**Central Station Main Works Project**  
CTMP Addendum 7 – Railway Colonnade Drive Rev 3

### Addendum 7

## Railway Colonnade Drive Rev 3

### Route of travel

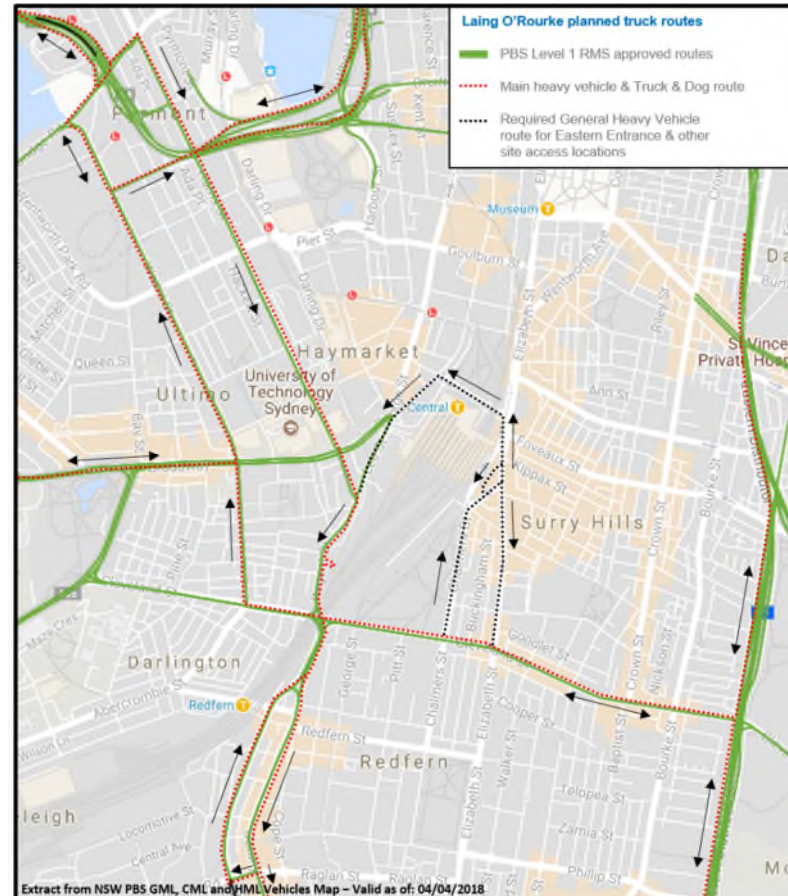
Route of travel	J.Coles	SCO	09-Sep-2019		The area proposed has very high pedestrian volumes. How will the conflict between pedestrians and heavy vehicles be managed on site?		Pedestrians and bicycles will only be diverted following consultation and approval from Central Station Precinct and Sydney Trains. Temporary signage is only installed by traffic control team during work window after obtaining approval from Central Station precinct and Sydney Trains	09.09.2019
